MY2 Monitoring Report

Owen Farms Mitigation Site
Transylvania County, NC

Re: MY2 Monitoring Report Comments
Owen Farms Stream and Wetland Mitigation Site
French Broad River Basin; CU# 06010105 – Transylvania County
DMS Project ID No. 100064
Contract No. 7532
SAW-2018-01165

Response to DMS Comments

CURRENT CONDITIONS PLAN VIEW
OWEN FARMS MITIGATION SITE
 FIGURE 2.1

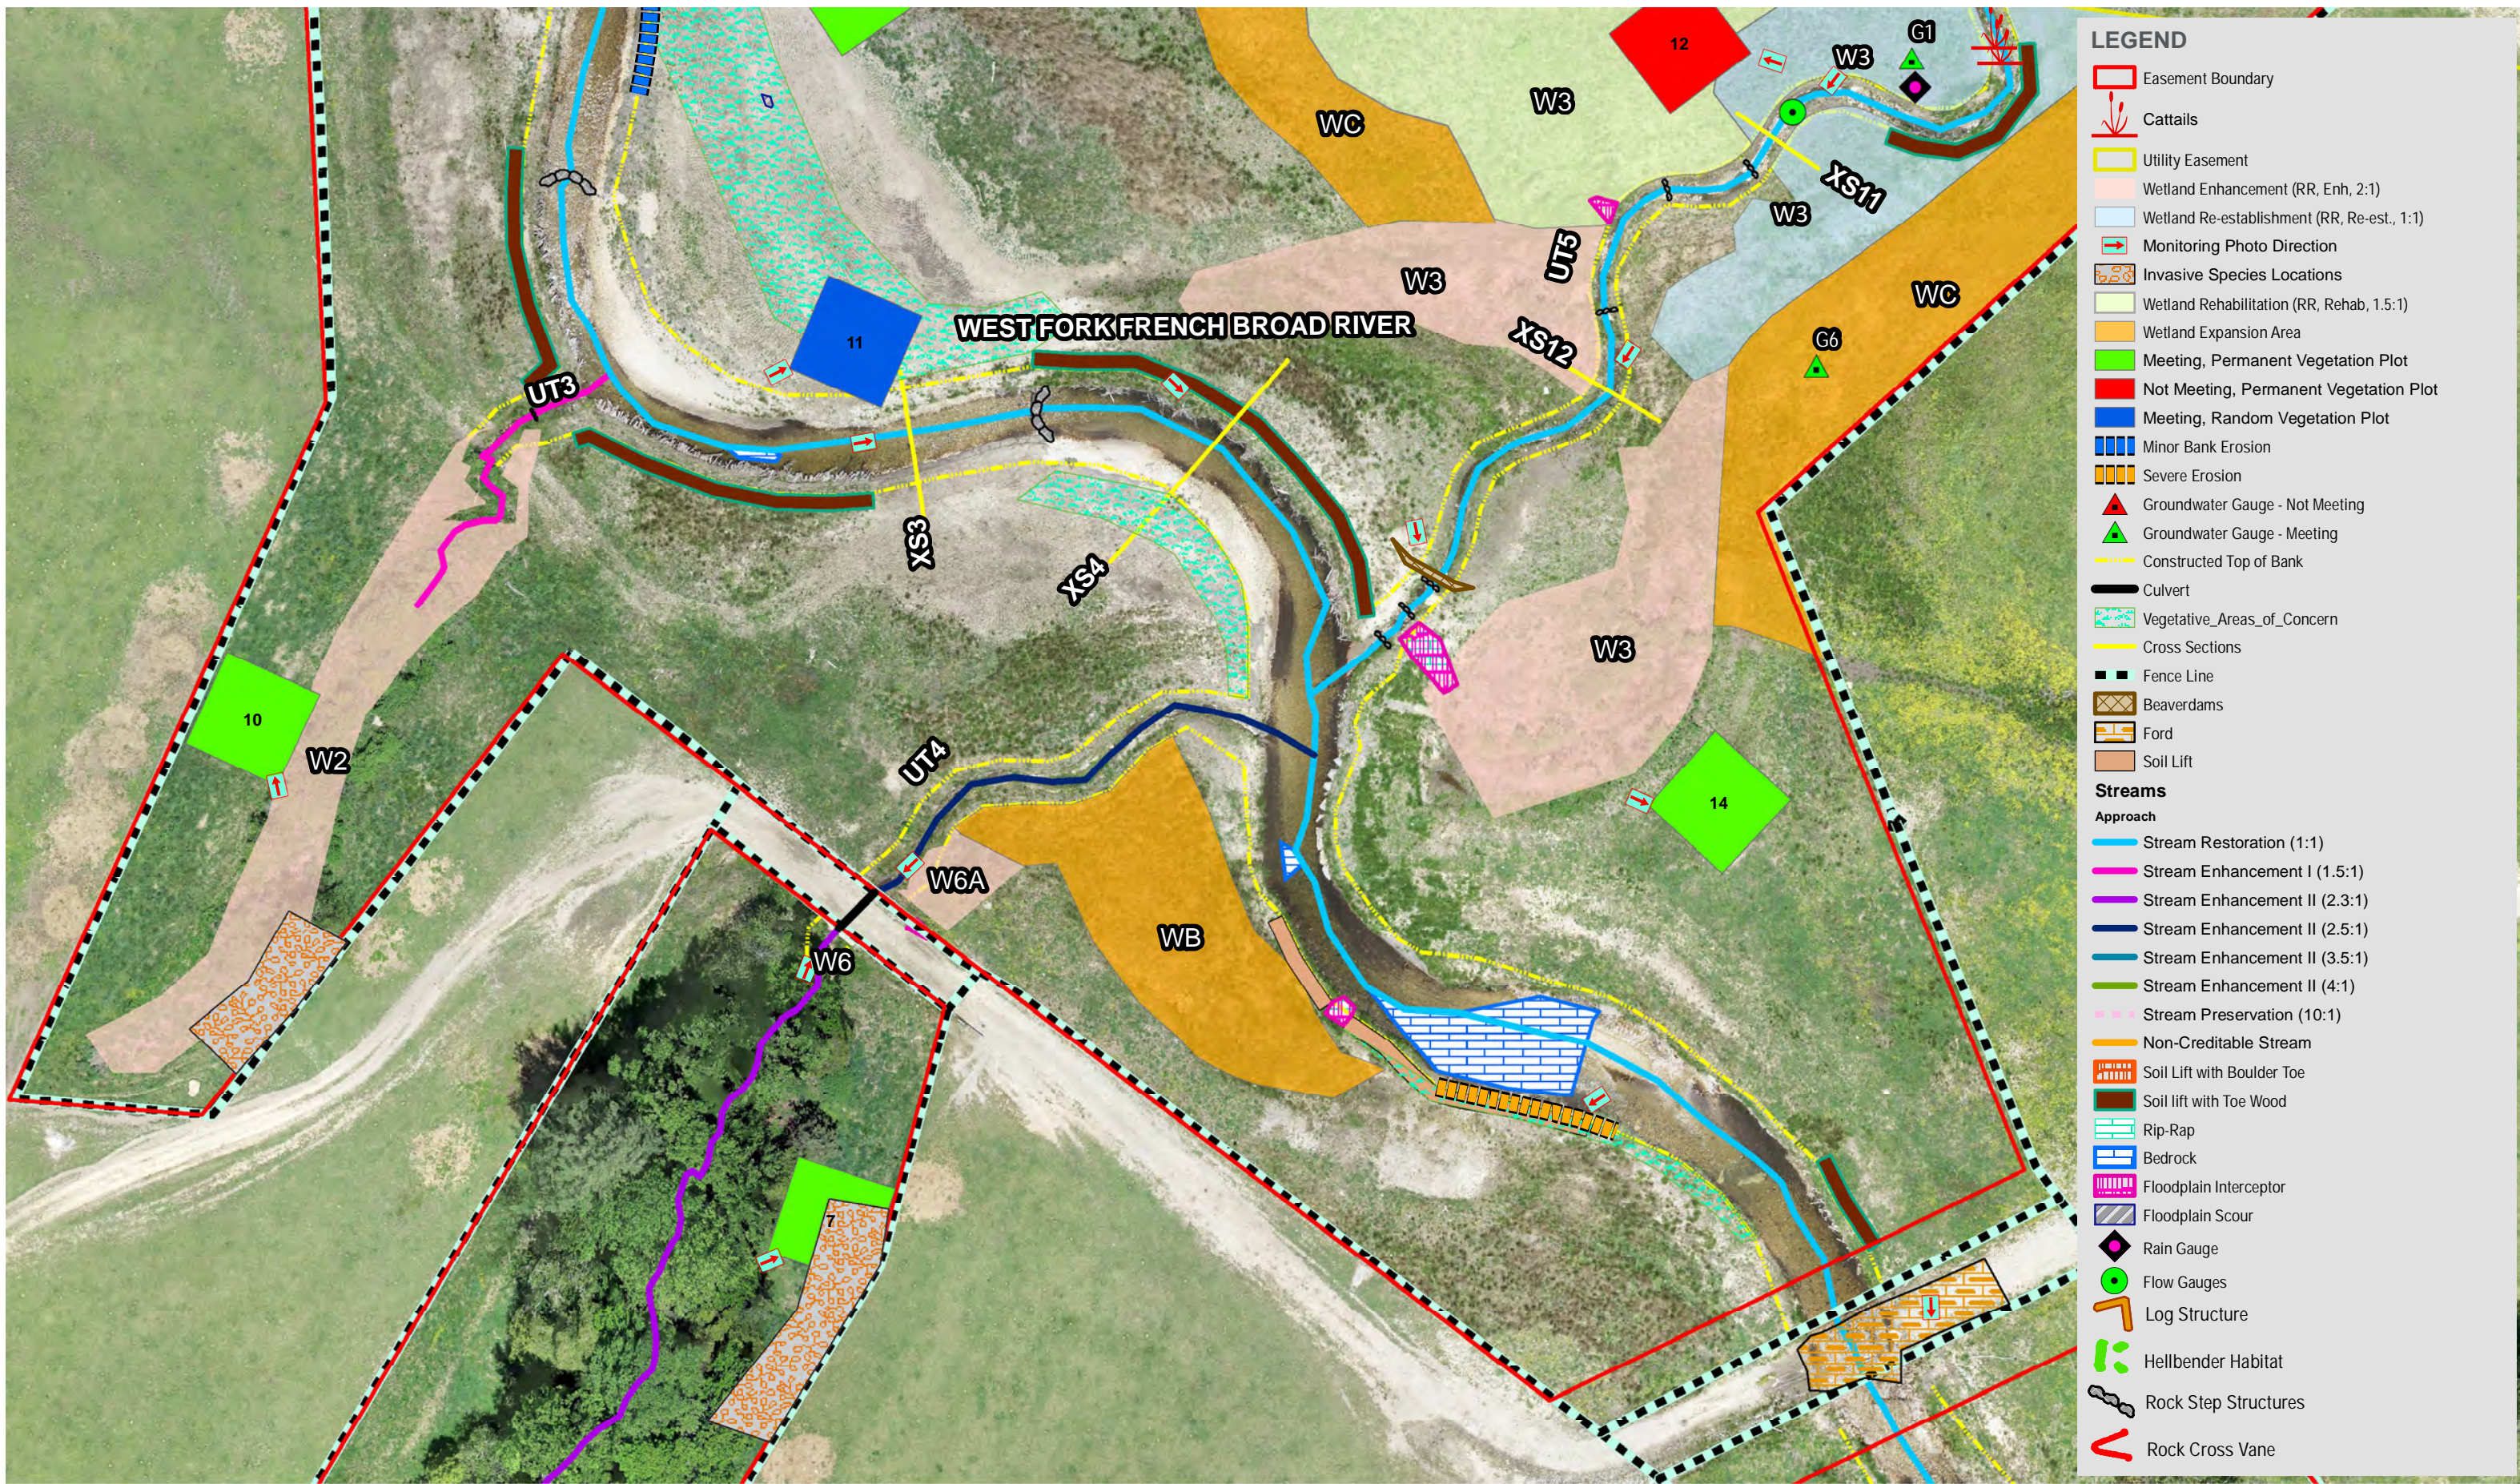
14: CCPV Maps: Please label the potential wetland expansion areas as identified in Appendix H – Wetland Expansion Area Letter to USACE. The CCPV has been updated to reflect labels on wetland expansion areas.

15: CCPV Maps: The random vegetation plots (11, 16, 19) should be identified as random plots on the CCPV Maps and legend. Were any the project's random plots located in MY1 replant areas as discussed with the IRT? Please discuss in the response letter and update the report text accordingly. Vegetation Plot 11 was located within the replant area. The CCPV has been updated to reflect random, permanent, meeting and not meeting.

**4.2 West Fork French Broad Cross
Section 2: 8/18/2022**

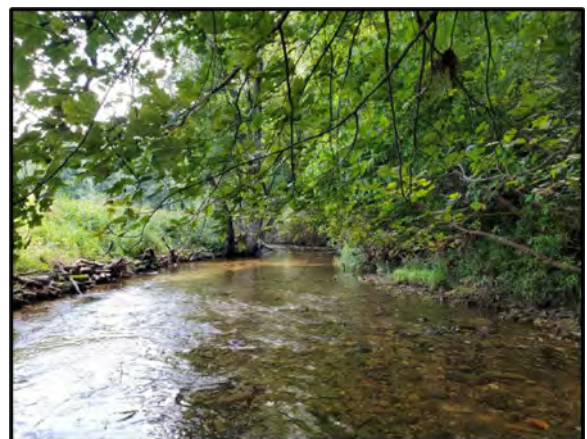
16: Figures 4.1 – 4.14 Cross Section Photos: Please include the photo dates taken in the photo captions. Dates have been added.

**Figure 7.1 West Fork French Broad River
Flow Depth**

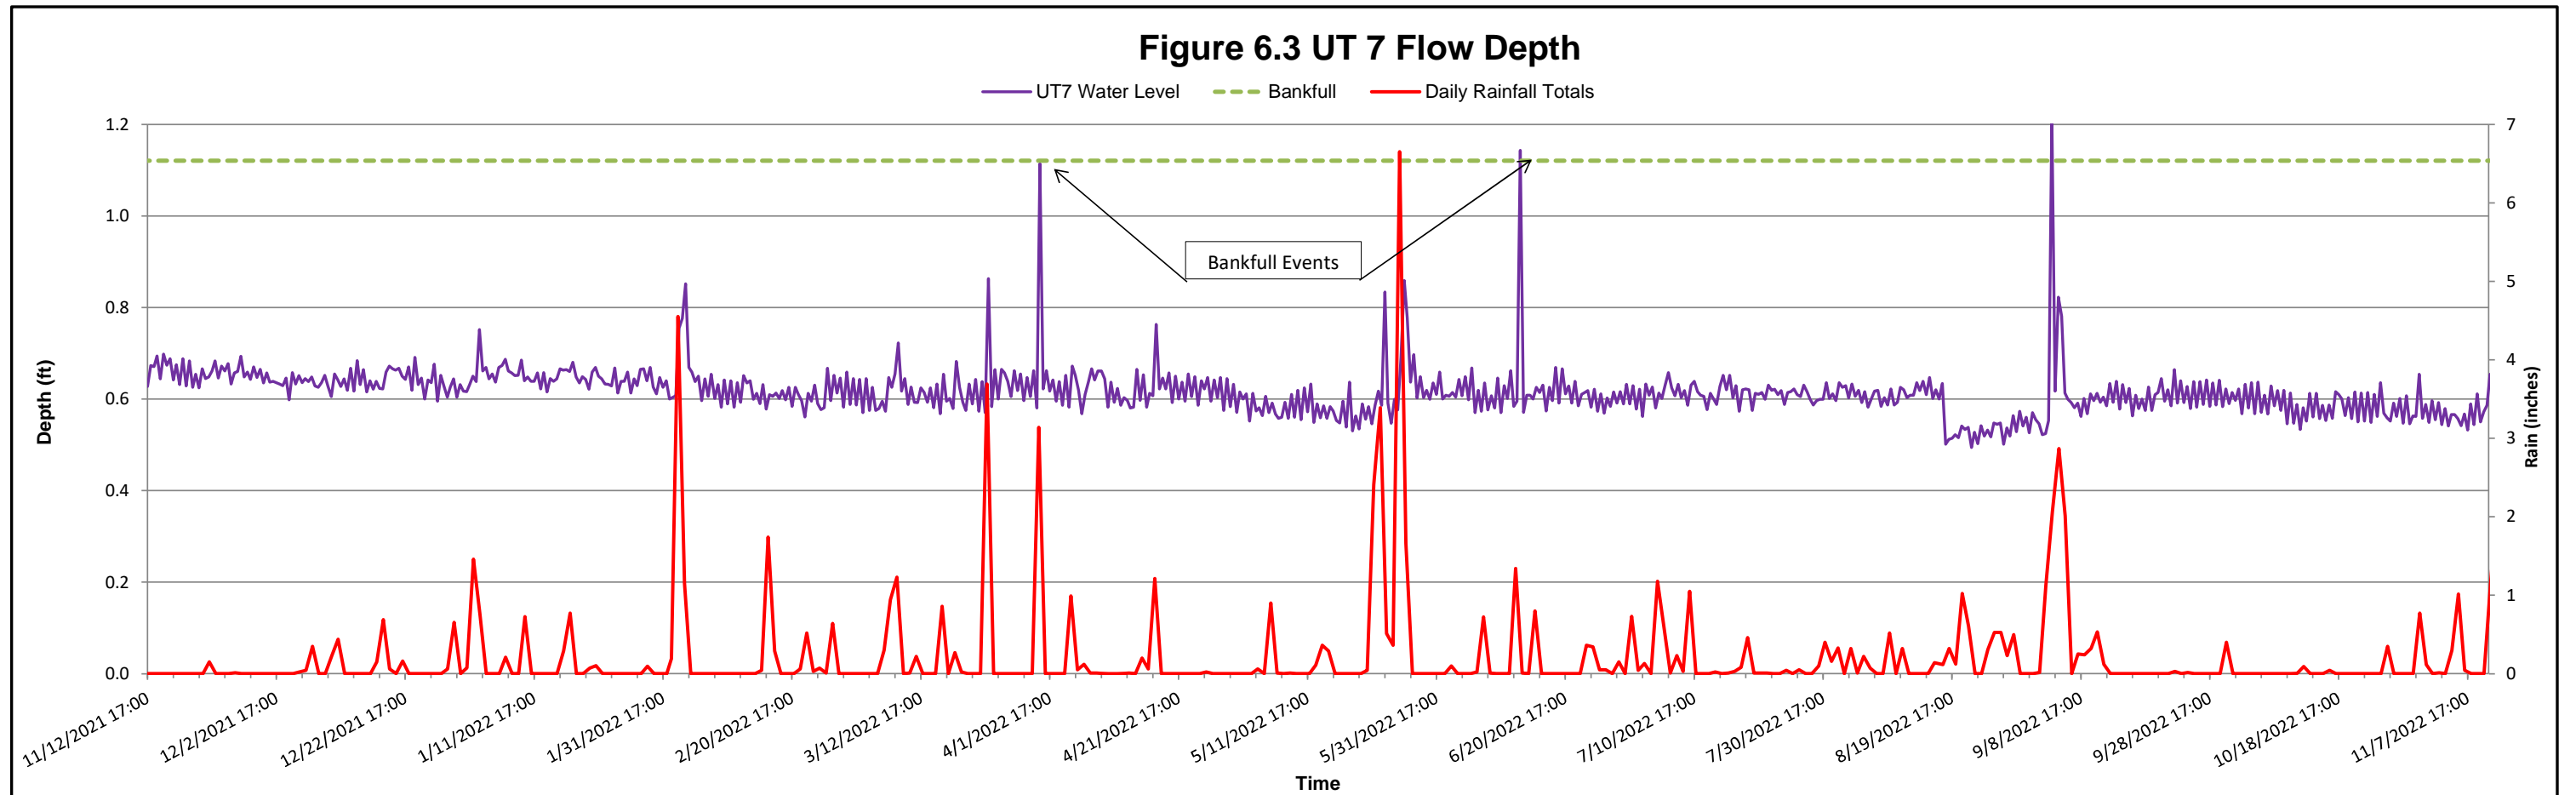
17: Figure 7.1- 7.4: Flow depth graphs: Please update the graphs to include all of the data from the MY2 (2022) growing season. *Data has been added.*

Figure 8.2: W3 Groundwater Gauge Data

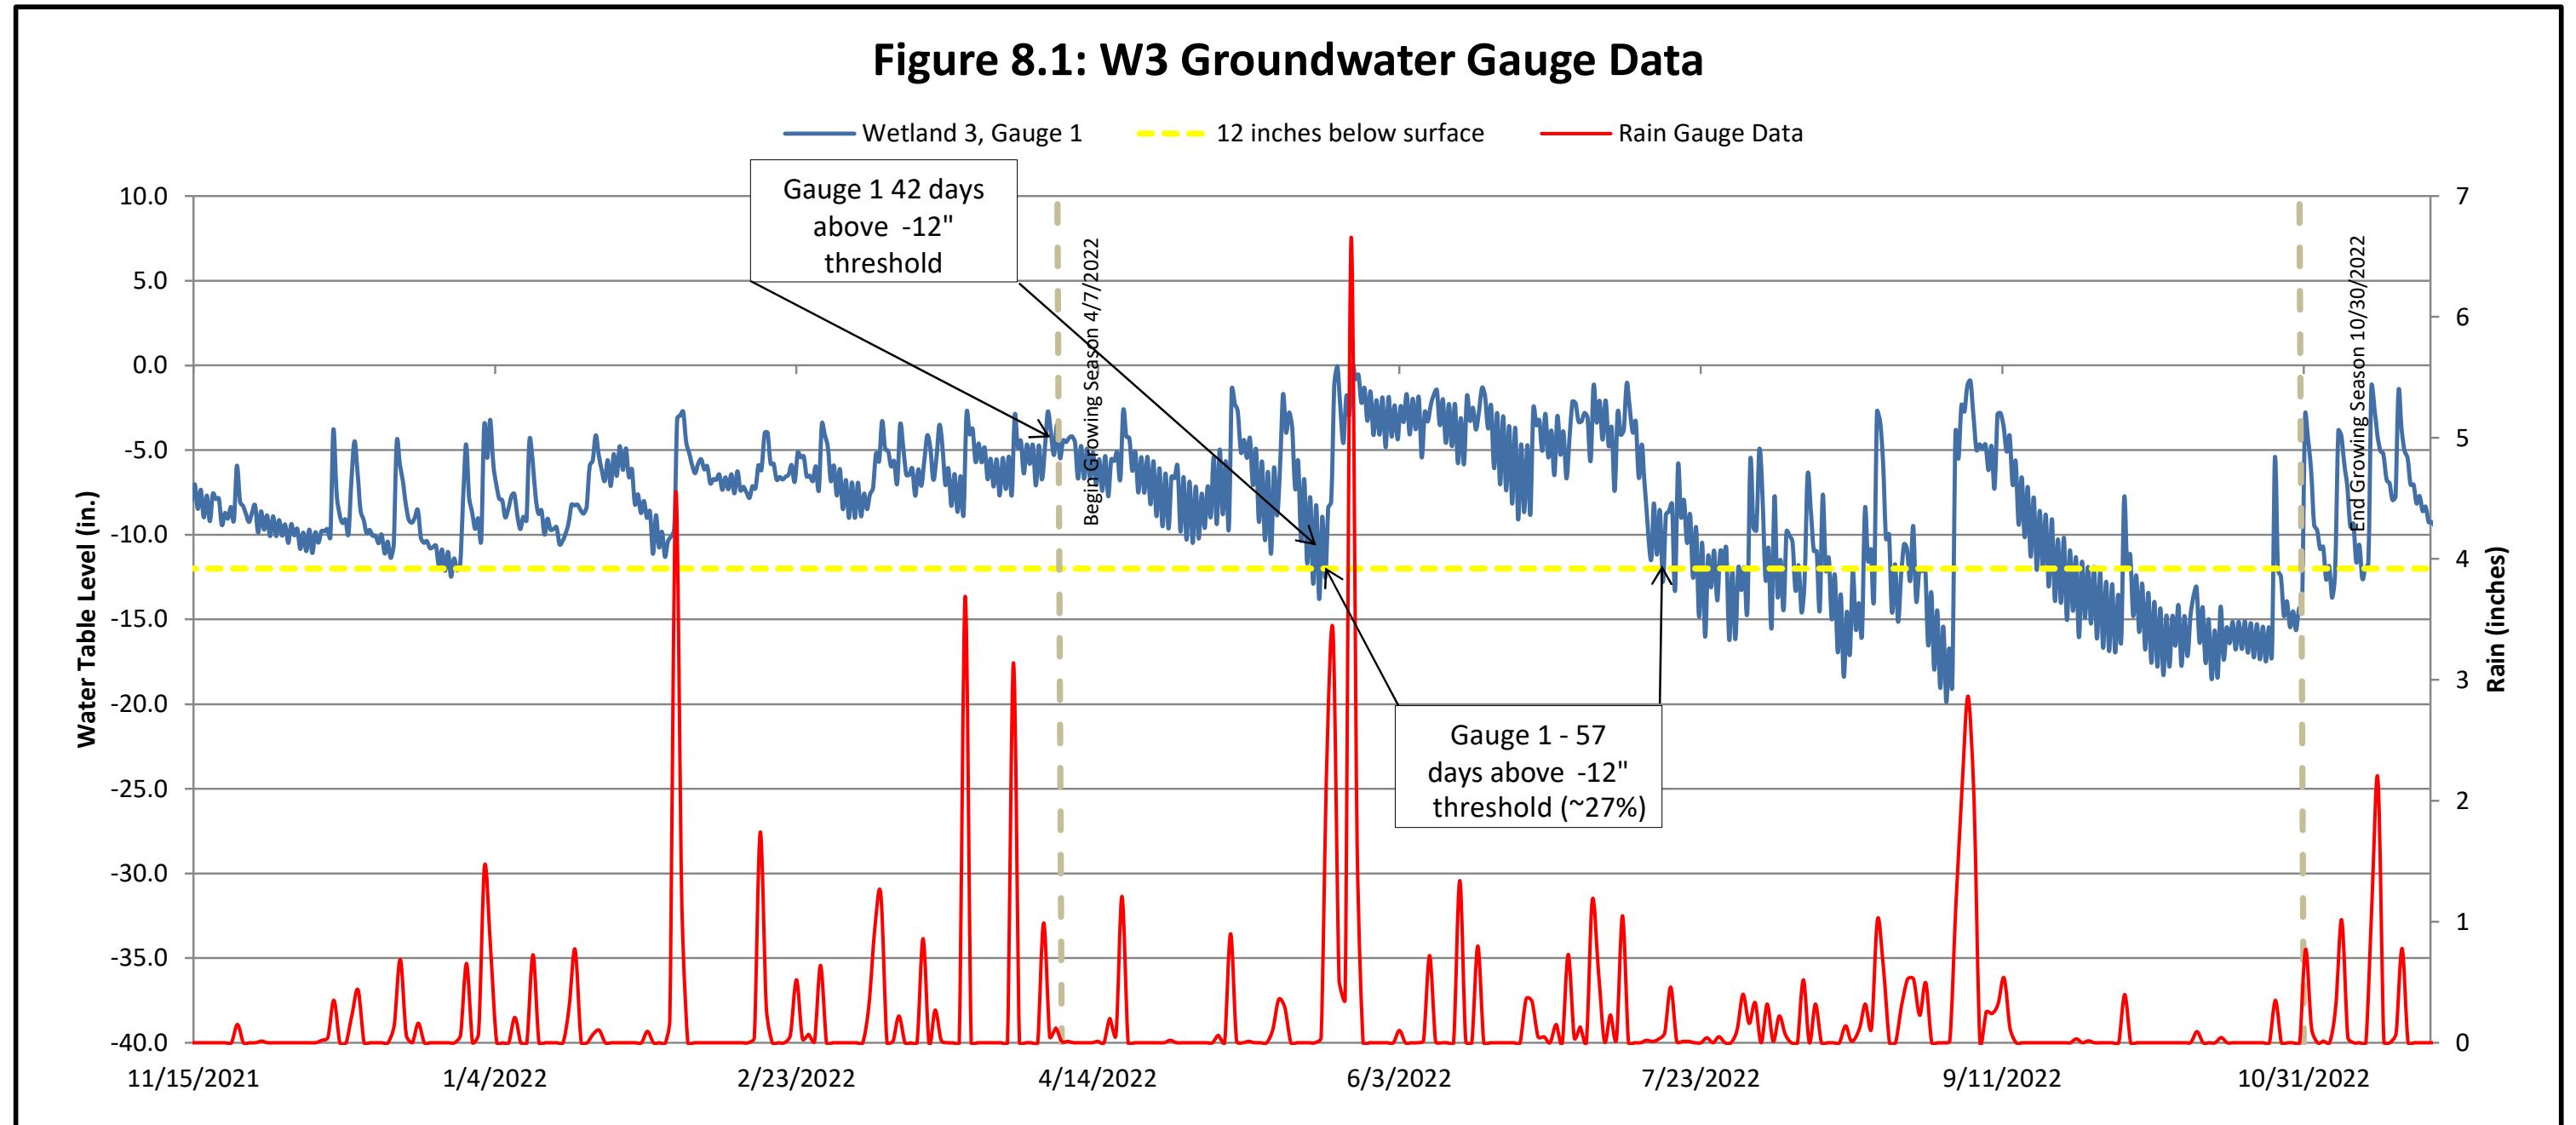
18: Figure 8.1- 8.6: Groundwater gauge data graphs: Please update the graphs to include all of the data from the MY2 (2022) growing season. Please also update each graph to include the percentage of the growing season based on the growing season dates established. *Data has been updated. Percentages were added to graphs and can be viewed in Table 14: Wetland Hydrology Summary.*
